**TOWN OF NEWBURGH
PLANNING BOARD
TECHNICAL REVIEW COMMENTS**

PROJECT NAME: POSITIVE DEVELOPERS WAREHOUSE
PROJECT NO.: 22-16
PROJECT LOCATION: 36 RACQUET ROAD
SECTION 86, BLOCK 1, LOT 26.31
REVIEW DATE: 12 MAY 2023
MEETING DATE: 18 MAY 2023
PROJECT REPRESENTATIVE: ENGINEERING AND SURVEYING PROPERTIES, PC

TREE PLAN

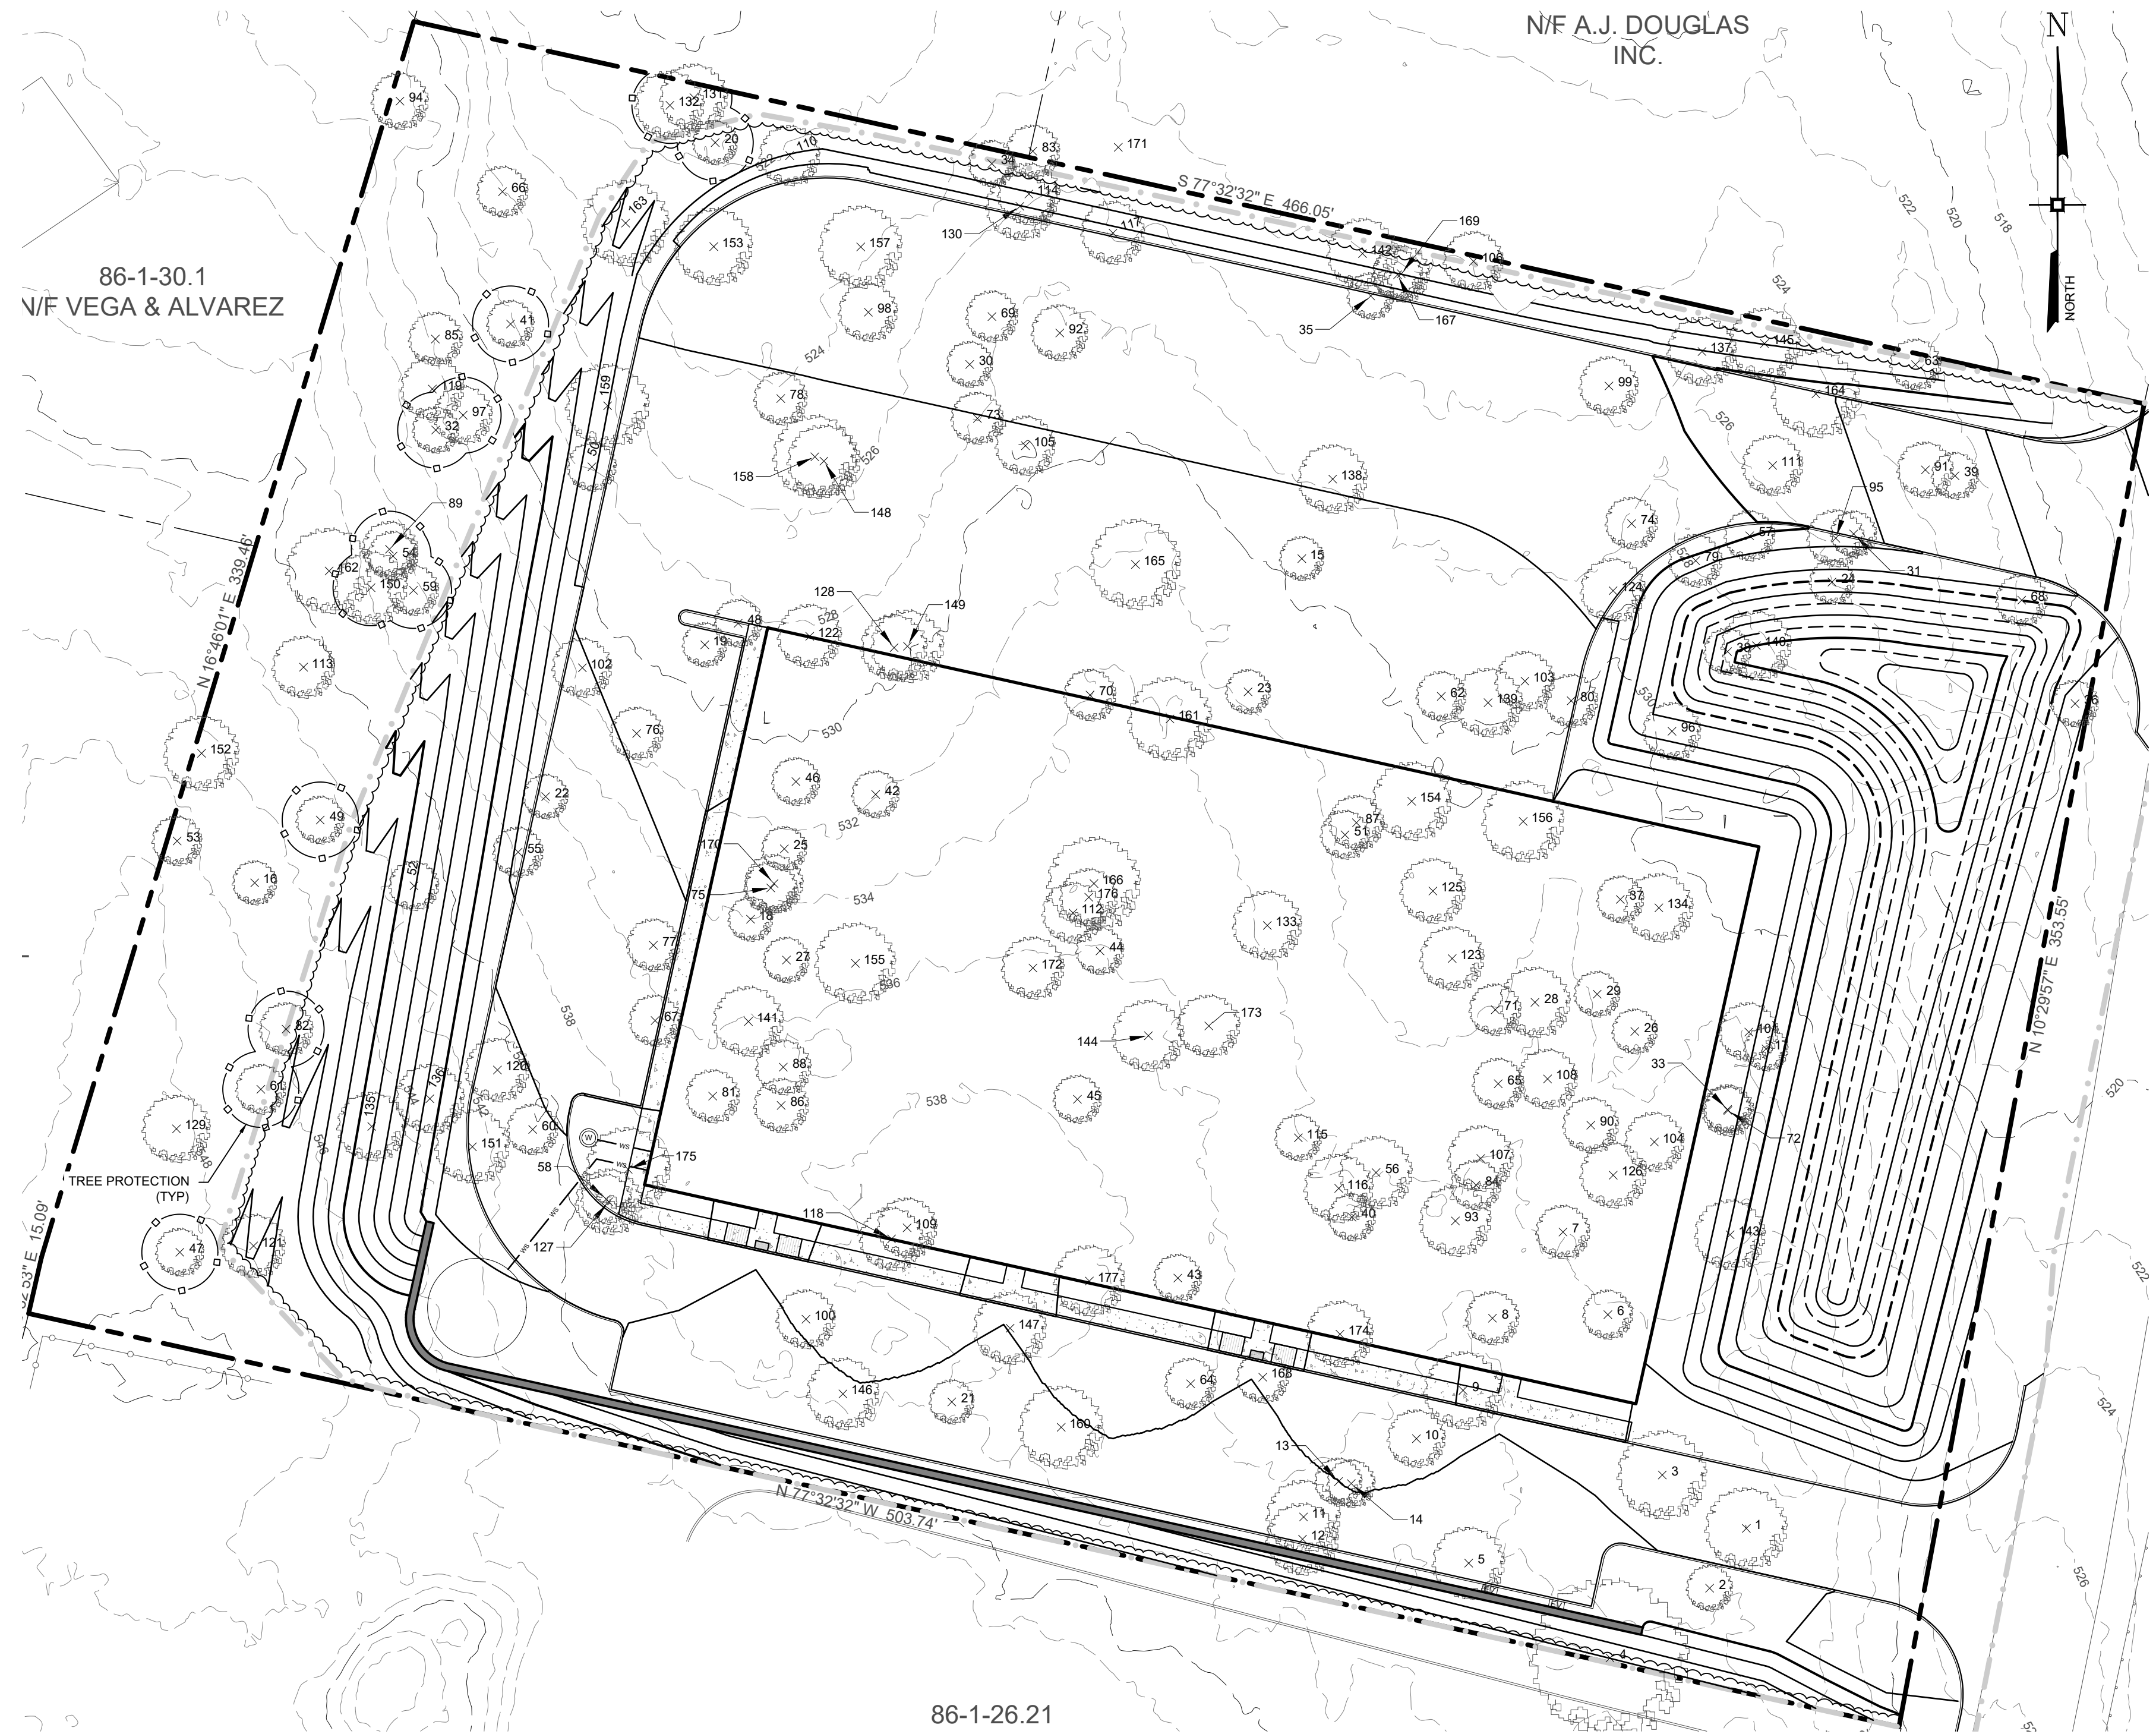
1. The Highway Superintendent's comments regarding the location of the access drive should be received.
2. A review of the Tree Preservation Plan submitted (Sheet 106) identifies the removal of 85.2% of the significant trees, 89.6% of specimen trees and 100% of the protected trees. A Mitigation Plan must be prepared for the percentage removals identified. A re-planting plan in compliance with the Tree Preservation Ordinance and/or monetary contribution must be identified. It is requested that the applicants Forestry Professional provide a Narrative Report on the Tree Preservation Plan and proposed mitigation.
